CONTRACT CHANGE ORDER NO. _____
SHEET ___ OF ___

SAN FRANCISCO OAKLAND BAY BRIDGE
EAST SPAN SEISMIC SAFETY PROJECT
SELF-ANCHORED SUSPENSION BRIDGE
(SUPERSTRUCTURE & TOWER)

GIRDER AT EAST TRANSITION NO.15

ELEVATION
LONGITUDINAL SHEAR PLATE TYPE 2
SECTION B-B

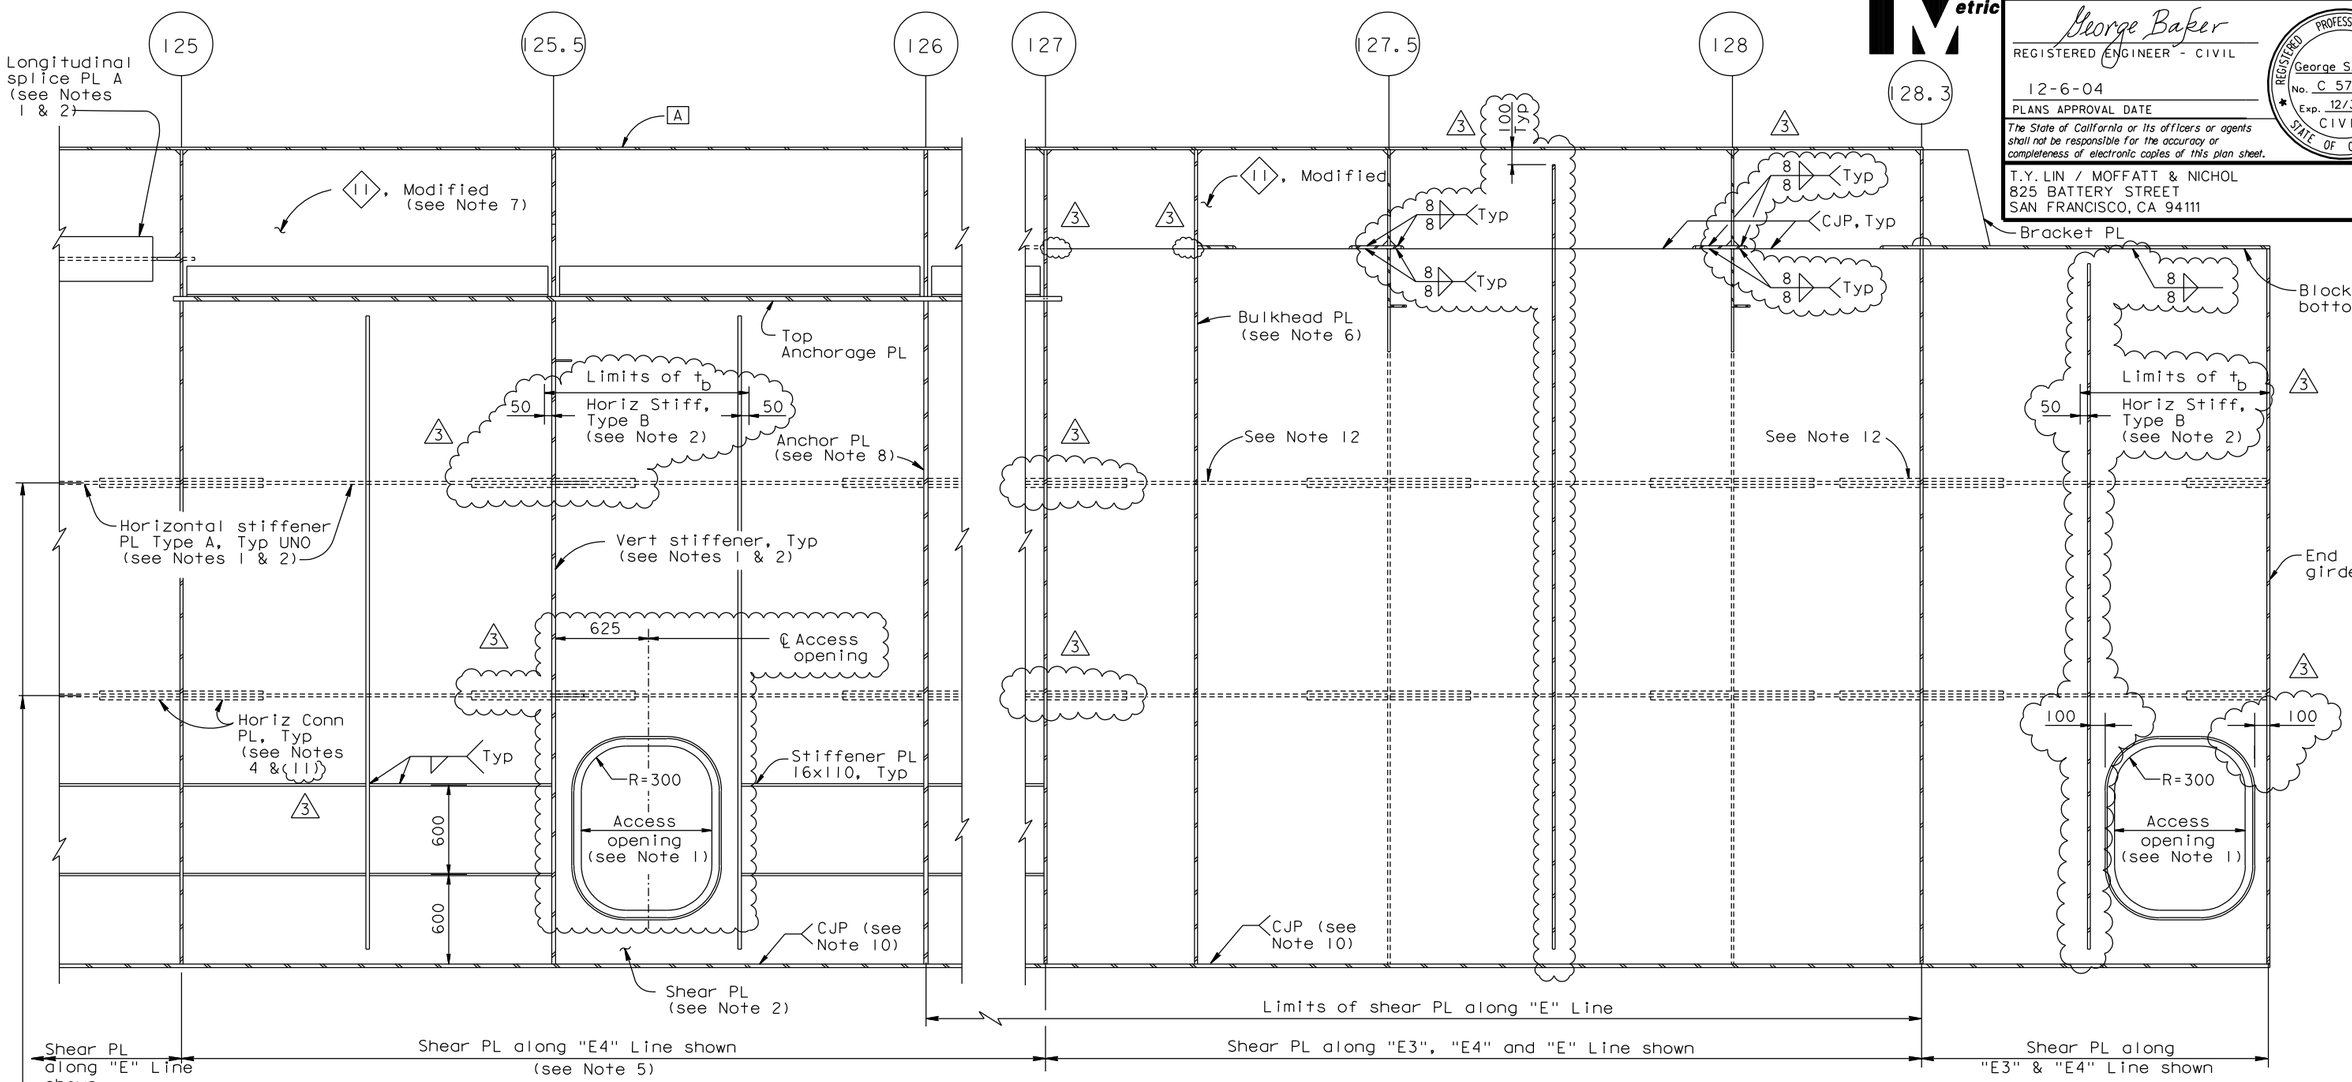
MARK	DATE	DESCRIPTIONS	BY	CH'D	CCO#
3	03/09/12	EAST END OBG	GB	MN	87
2	07/31/09	LONGITUDINAL SHEAR PLATE	DT	GB	122
1	07/30/07	HINGE A REACTION-SHEAR PLATES	DT	GB	50

10. The longitudinal shear PL to girder face "D" weld shall be a CJP from the CL splice near PP111 to PP128.7.
11. Horizontal connection detail applies only where existing floorbeam horizontal stiffeners coincide with shear PL stiffeners. (3)
